Responses to editor and reviewers

Thanks very much for taking your time to review this manuscript entitled “The formation and geometry characteristics of boulder bars due to outburst flood triggered by the overtopped landslide dam failure” (Esurf-2020-92). I appreciate all your and reviewers’ comments and suggestions! Those comments are constructive for us to revise and improve our paper. We have read these comments carefully and tried our best to revise and improve the manuscript. The revised contents have been highlighted in blue in the revision. The followings are the point-to-point response for each comment. We hope our revision will make the manuscript acceptable for publication. Thanks again!

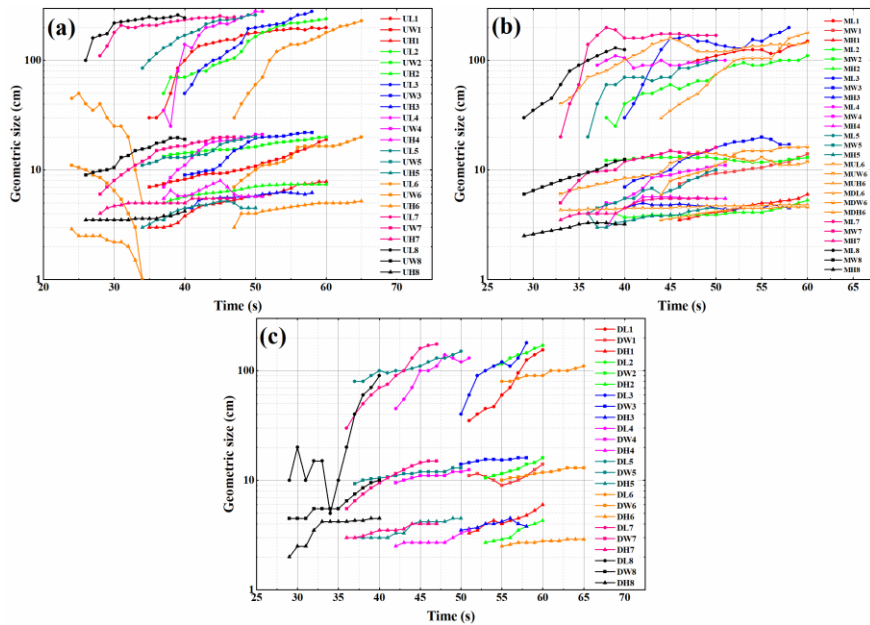
Figure 6: consider a log scale for the y-axis so that the width and height data are easier to see.

Thanks a lot for the reviewer's suggestion. We have adjusted Figure 6 as follows:

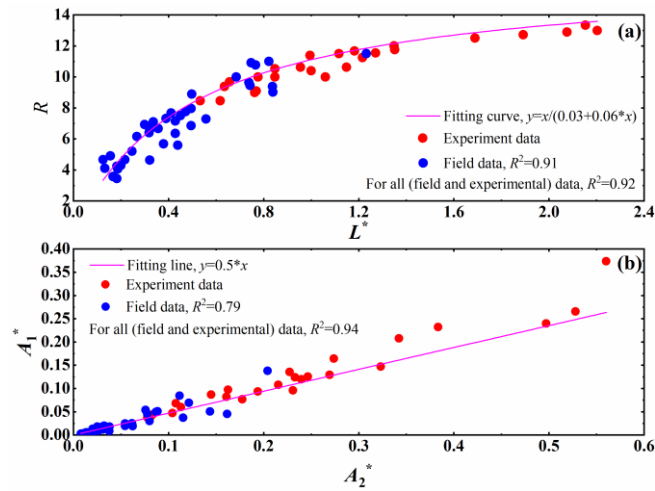
Figures 8 and 10 are a nice addition to this study: consider plotting the flume data on the field data plot in figure 10 to show how well they compare

Thanks a lot for the reviewer's suggestion. We have plotted the flume data on the field data plot in figure 10. It shows the two groups of data are compared well.
